Westinghouse Electric Company
Nuclear Power Plants
P.O. Box 355
Pittsburgh, Pennsylvania 15230-0355
USA

SUBJECT: Transmittal of Responses to AP1000 DSER Open Items

Draft Safety Evaluation Report Open Item Response

Figure 9 – Isometric View: Comparison of AP600 and AP1000 DVI-A Piping System

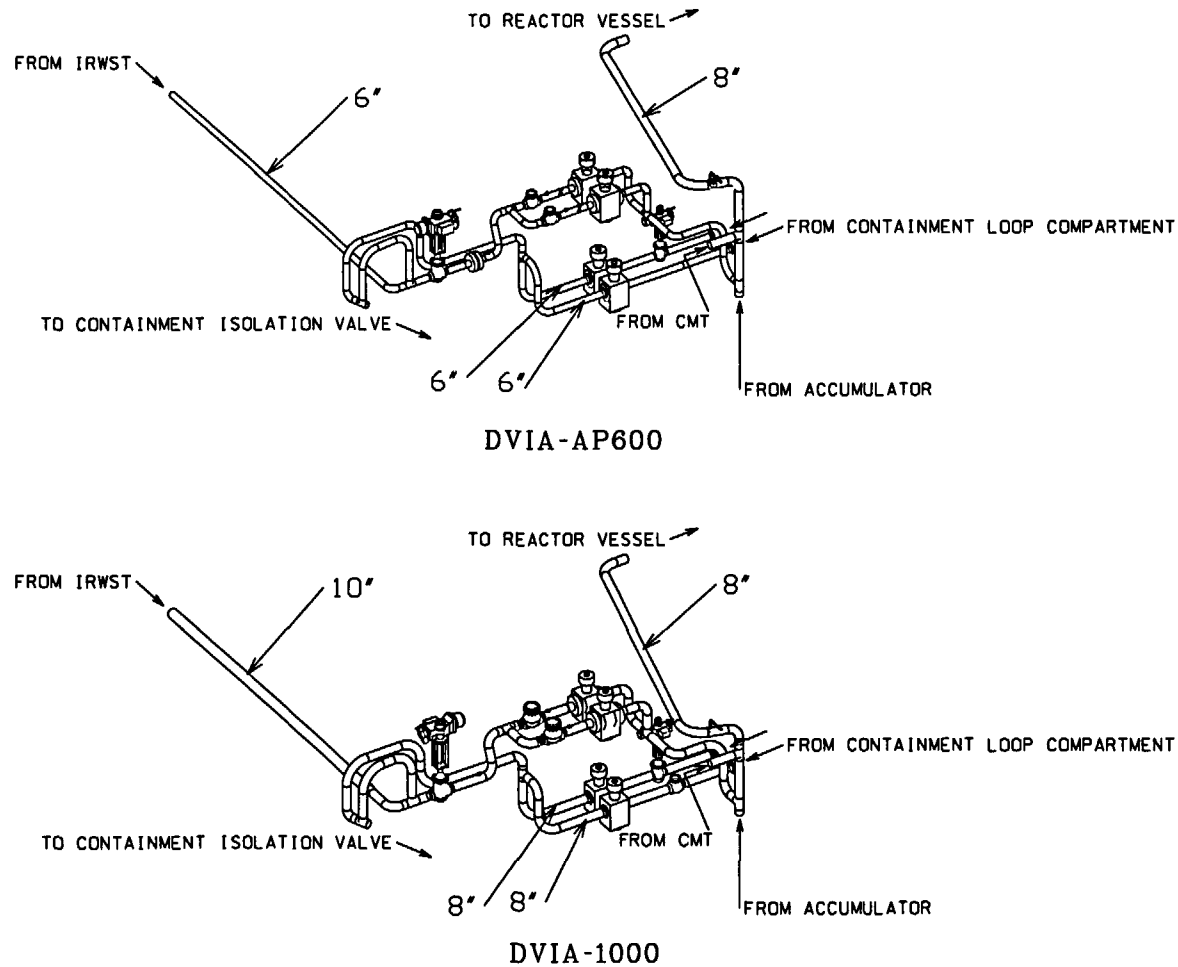
Complexity of piping system - The DVI-A piping system is complex, and was particularly challenging to qualify for the AP600. The AP600 design and analysis of the DVI-A subsystem was performed over several iterations that included perturbations in the piping layout, support configuration, and piping analysis. Figure 9 shows isometric views of both the AP600 and AP1000 DVI-A piping system.

Low Margin to BAC for AP600 - The AP600 analysis results for the DVI-A line exhibited low margin to the AP600 BAC limits. In addition, the limit for one particular line segment actually exceeded the BAC. (For that segment, engineering judgement was used to determine that modification of the final support configuration would result in reducing the stress limits to below the BAC for that line segment). Therefore it is expected that the DVI-A would be one of the most difficult piping systems to qualify for LBB for the AP1000.

Figure 22 - Pressurizer Safety Valve Inlet Pipe Break Protection (Sheet 1 of 2)

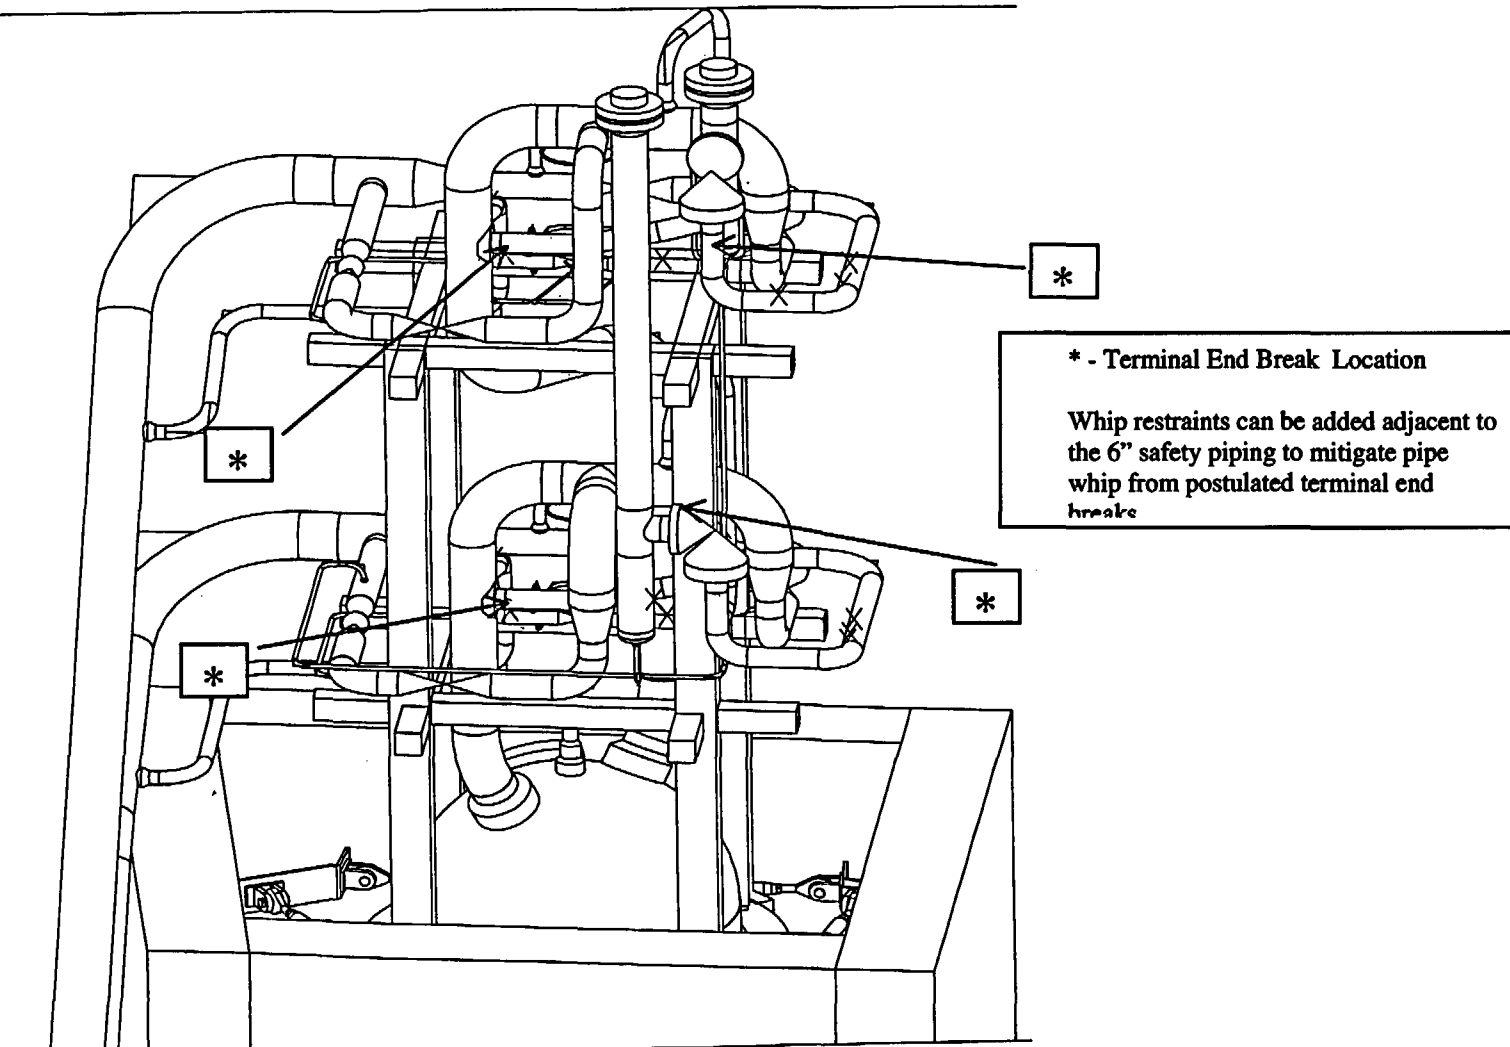
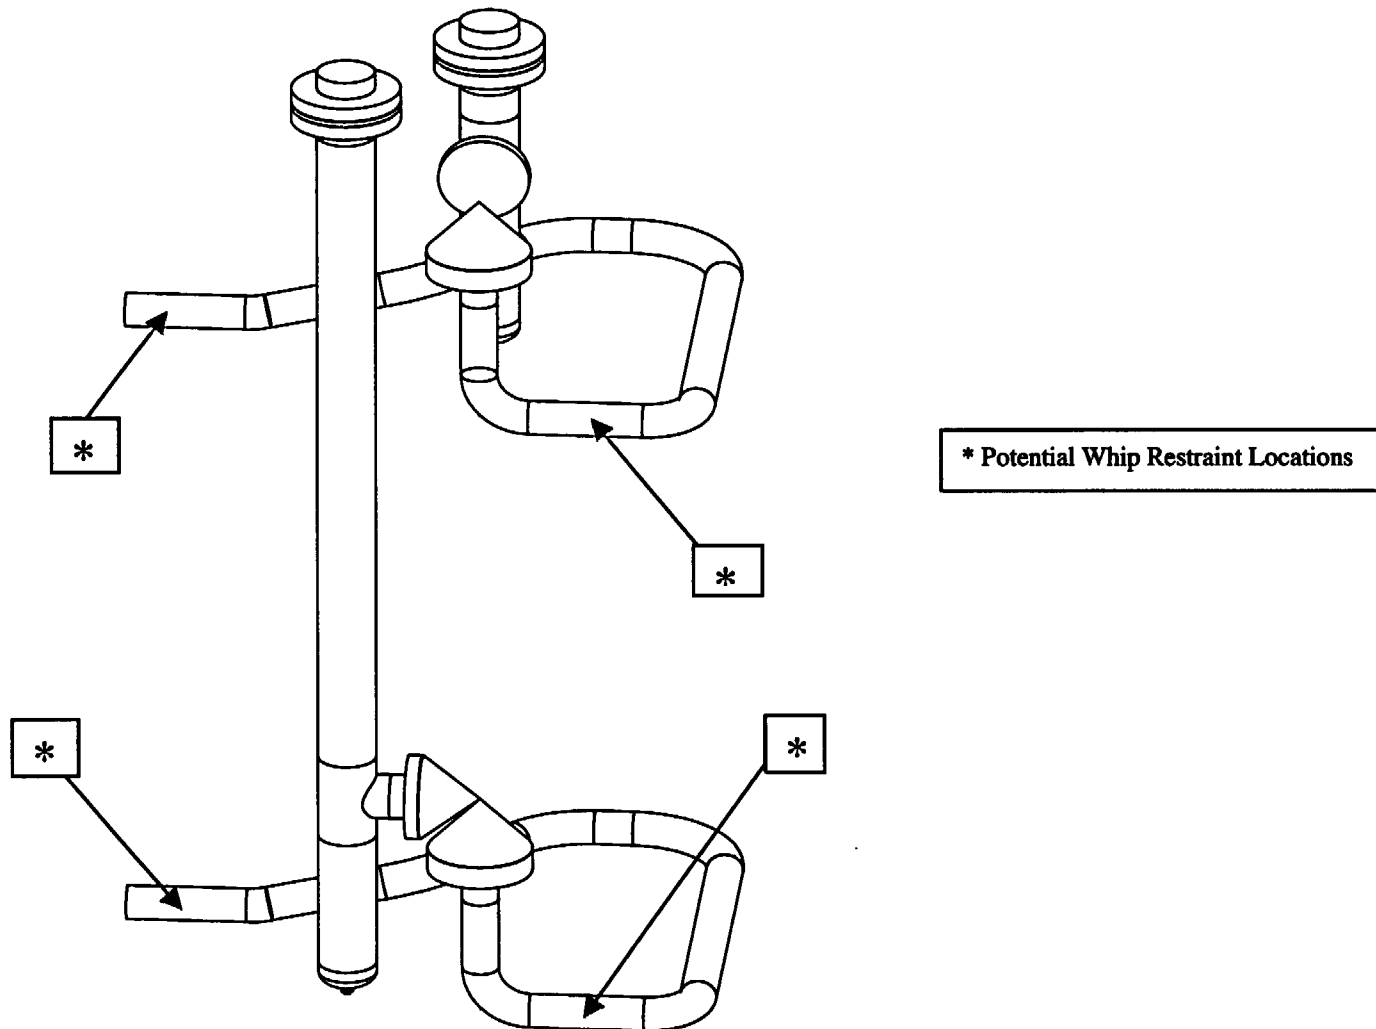
The Pressurizer Safety pipe diameter is the same as AP600. The seismic multiplication factor is 2.71. This includes the affect of the higher elevation of the pressurizer upper lateral support. The maximum stress is 61.9 ksi which is higher than the BAC stress of 40.4 ksi. Figure 21 shows the BAC and the estimated stresses for the AP1000 plant. This stress is calculated based on the conservative methods previously described in Section 2. Utilizing detailed time-history seismic analysis methods as opposed to response spectra methods previously utilized for AP600, it is anticipated that the analytical results will be significantly lower than those obtained by the conservative ratios developed. In the event that the results from the detailed time-history seismic results still exceed the BAC limits, the affects of postulated high energy line pipe breaks in the two 6" Safety lines would need to be evaluated. These pipe breaks are above the top of the Pressurizer subcompartment walls, and do not effect the design for subcompartment pressurization. Therefore the breaks would not have any adverse impact on the structural design of the Containment Internal Structure. Pipe whip restraints can be installed on the ADS pressurizer platforms at the locations shown in Figure 22 to ensure that the adjacent components that are needed to mitigate the pipe break (i.e. ADS Stage 1, 2, and 3 valves and piping) are not compromised.

This report summarizes an assessment of applying Leak-Before-Break methodology to the candidate AP1000 plant pipe lines listed in Table 1. Feasibility is demonstrated for the LBB candidate piping systems with one possible exception of the Pressurizer Safety Valve inlet piping (6"). For these two lines, the high energy pipe breaks can be mitigated by the installation of protection devices (whip restraints) as shown at the locations in Figure 22 if required.

Figure 27 - Bounding Analysis Curve – Normal RHR Suction – 12"

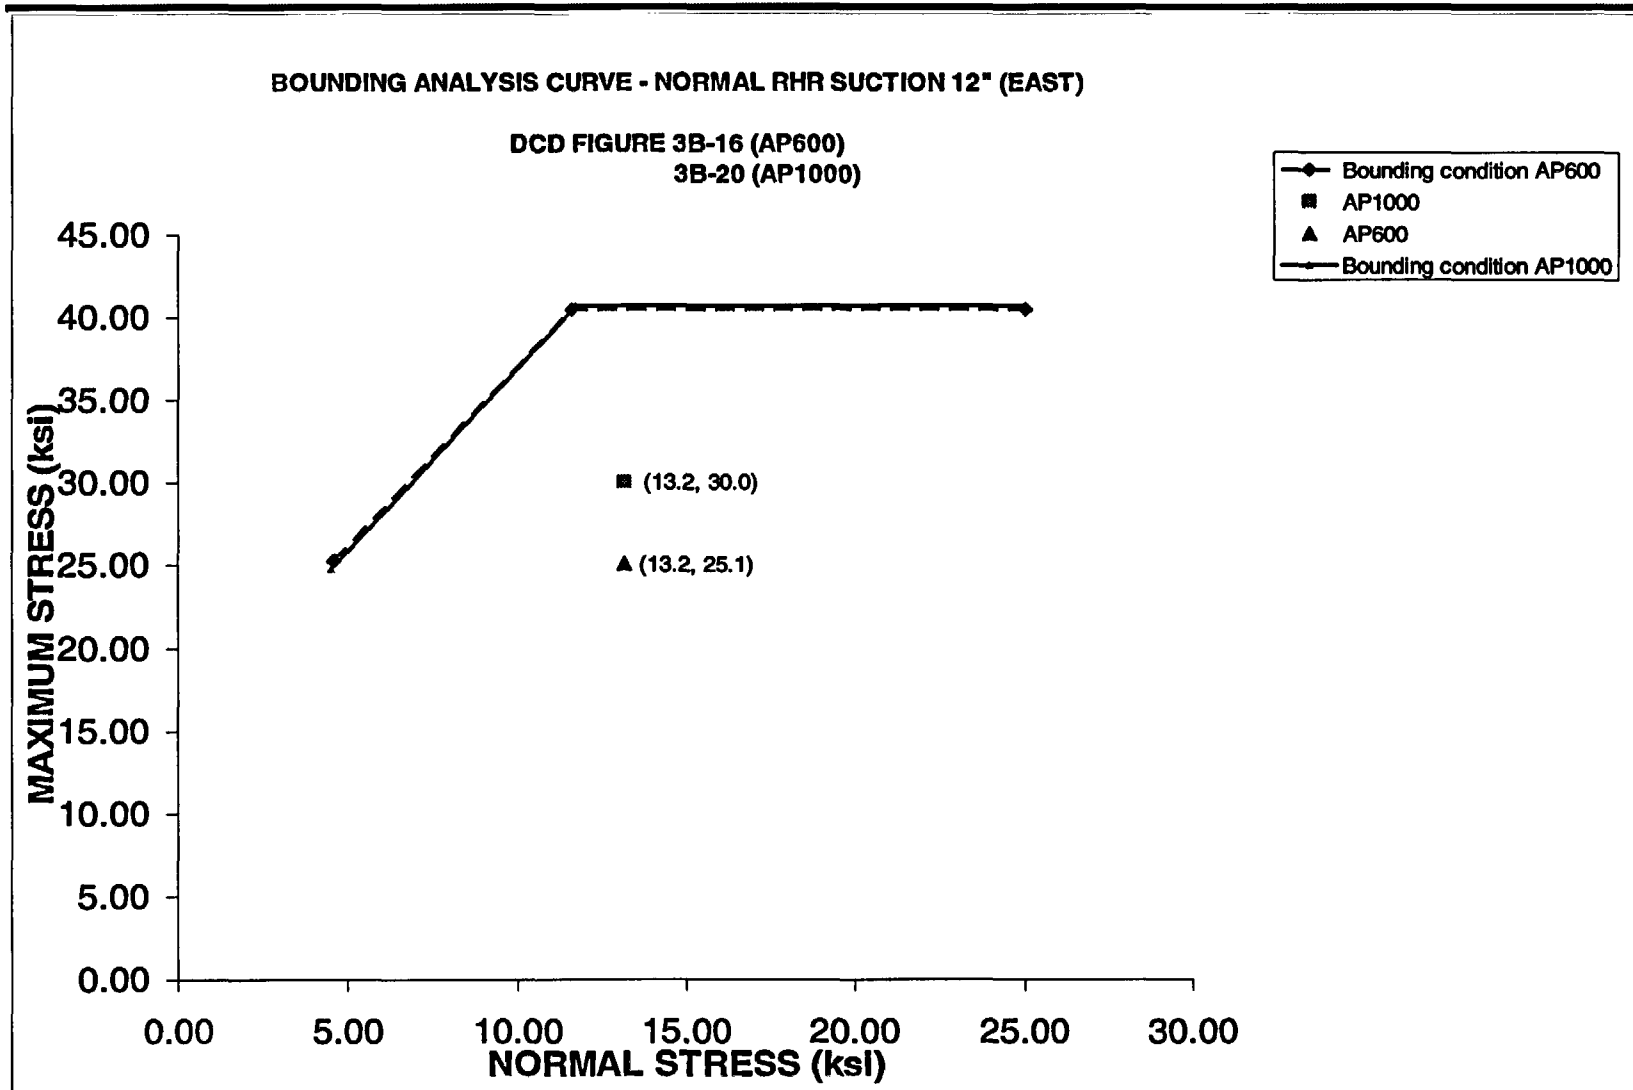
support in the East subcompartment. The maximum stress is 30.0 ksi which is less than the BAC stress of 40.7 ksi. Figure 27 shows the BAC and the estimated stresses for the AP1000 plant. The feasibility of LBB for AP1000 is confirmed.

Figure 38 : Bounding Seismic Increase Factors -
Seismic Response Spectra, Steam Generator Support Elev. 135', (North-South) – 4th Stage ADS

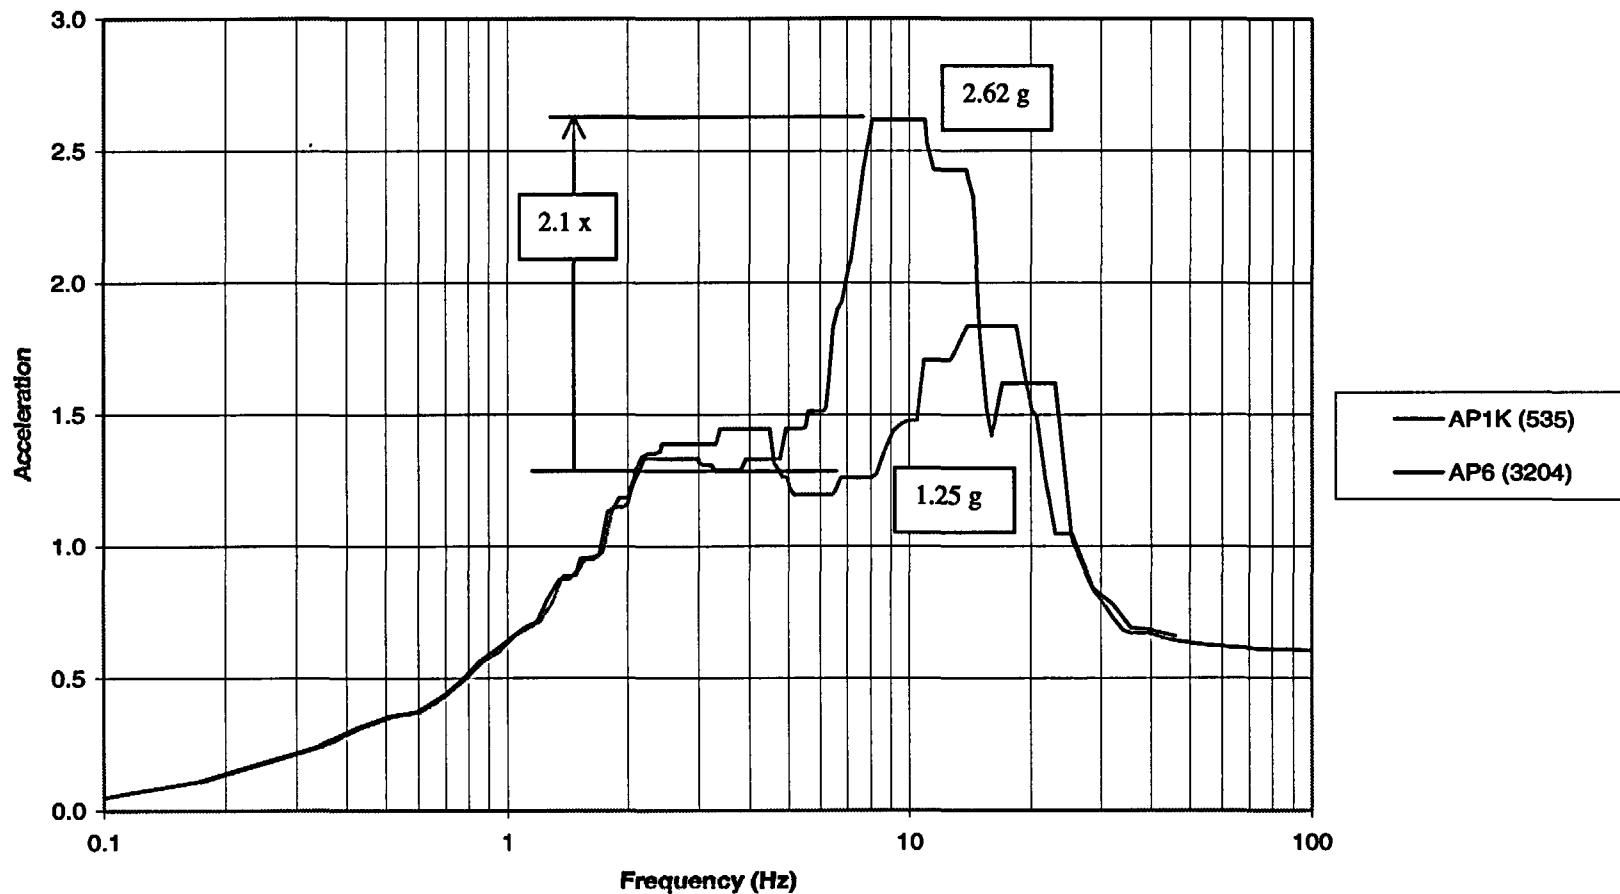
Due to the critical nature of this system, an additional assessment of the seismic loadings is performed to further demonstrate the feasibility of Leak-Before-Break for these lines. The applicable seismic response spectra are reviewed for the 4th stage ADS, East and West, and the maximum increase in response spectra acceleration identified based on individual frequency. This review results in the following seismic increase factors as shown in Figures 38 and 39:

The ADS Stage 4 pipe diameter is larger than the AP600 (12"). Per Figure 38, the seismic increase factor is 2.1 based on the seismic response spectra at approximately 8 Hz. The maximum stress is 33.0 ksi accounting for both the seismic increase factor and the increase in pipe diameter. The adjusted stress is less than the BAC stress of 40.7 ksi. Figure 40 shows the BAC and the estimated stresses for the AP1000 plant. Feasibility of LBB for AP1000 is confirmed.

The ADS Stage 4 pipe diameter is larger than the AP600 (10"). Per Figure 38, the seismic increase factor is 2.1 based on the seismic response spectra at approximately 8 Hz. The maximum stress is 38.0 ksi accounting for both the seismic increase factor and the increase in pipe diameter. The adjusted stress is less than the BAC stress of 40.7 ksi. Figure 41 shows the BAC and the estimated stresses for the AP1000 plant. Feasibility of LBB for AP1000 is confirmed.

The ADS Stage 4 pipe diameter is larger than the AP600 (10"). Per Figure 38, the seismic increase factor is 2.1 based on the seismic response spectra at approximately 8 Hz. The maximum stress is 36.5 ksi accounting for both the seismic increase factor and the increase in pipe diameter. The adjusted stress is less than the BAC stress of 51.9 ksi. Figure 42 shows the BAC and the estimated stresses for the AP1000 plant. Feasibility of LBB for AP1000 is confirmed.

Figure 39 : Bounding Seismic Increase Factors
Seismic Response Spectra, Steam Generator Support Elev. 153' (East-West) – 4th Stage ADS

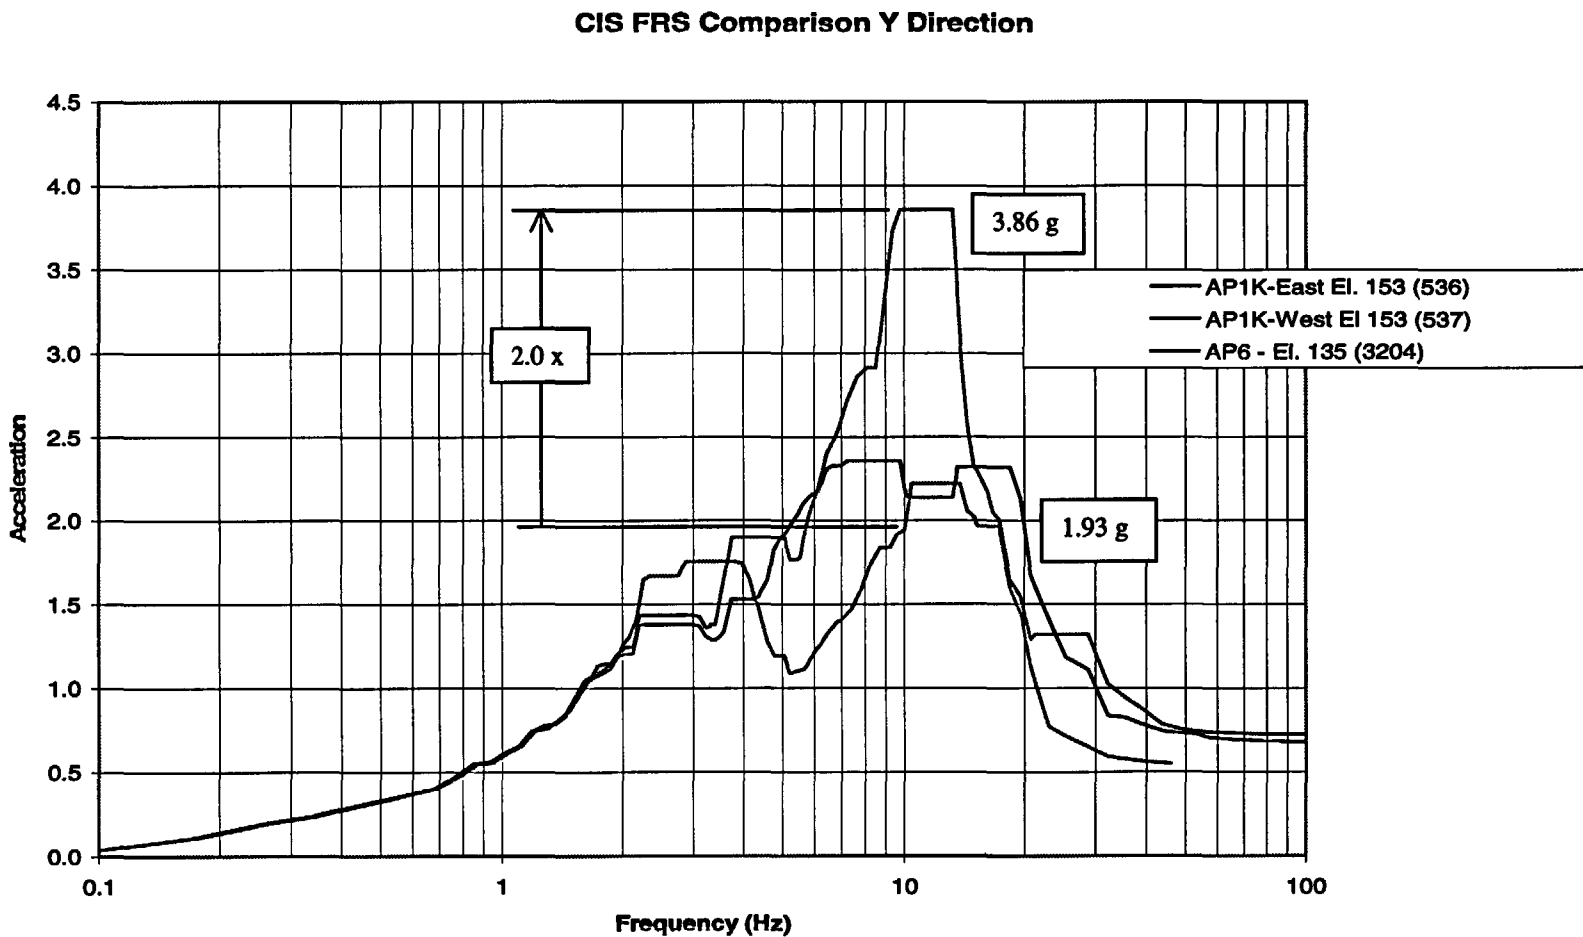
The ADS Stage 4 pipe diameter is larger than the AP600 (12"). Per Figure 39, the seismic increase factor is 2.0 based on the seismic response spectra at approximately 10 Hz. The maximum stress is 23.7 ksi accounting for both the seismic increase factor and the increase in pipe diameter. The adjusted stress is less than the BAC stress of 40.7 ksi. Figure 40 shows the BAC and the estimated stresses for the AP1000 plant. Feasibility of LBB for AP1000 is confirmed.

The ADS Stage 4 pipe diameter is larger than the AP600 (10"). Per Figure 39, the seismic increase factor is 2.0 based on the seismic response spectra at approximately 10 Hz. The maximum stress is 30.0 ksi accounting for both the seismic increase factor and the increase in pipe diameter. The adjusted stress is less than the BAC stress of 31.6 ksi. Figure 41 shows the BAC and the estimated stresses for the AP1000 plant. Feasibility of LBB for AP1000 is confirmed.

The ADS Stage 4 pipe diameter is larger than the AP600 (10"). Per Figure 39, the seismic increase factor is 2.0 based on the seismic response spectra at approximately 10 Hz. The maximum stress is 26.4 ksi accounting for both the seismic increase factor and the increase in pipe diameter. The adjusted stress is less than the BAC stress of 51.9 ksi. Figure 41 shows the BAC and the estimated stresses for the AP1000 plant. Feasibility of LBB for AP1000 is confirmed.

Figure 1: Cold Water Droplet Size Sensitivity

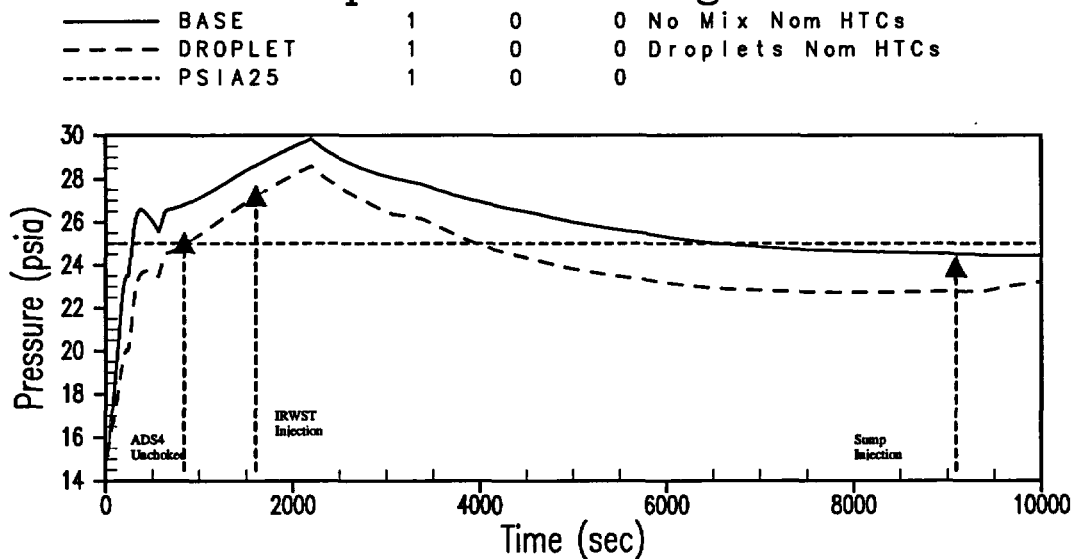
Figure 1 shows the containment pressure response for the two cases. By allowing the cold water to interact with the steam and two-phase mixture in the compartment vapor space, the overall pressure is reduced by approximately 2 psi. The pressure remains above 25 psia between the time that the ADS4 flow becomes non-critical and the time of IRWST injection. The interaction between the steam and the water droplets in the compartment causes steam to condense resulting in less steam to pressurize the containment. In addition, the water droplets are heated so that the water accumulating on the compartment floor is saturated.
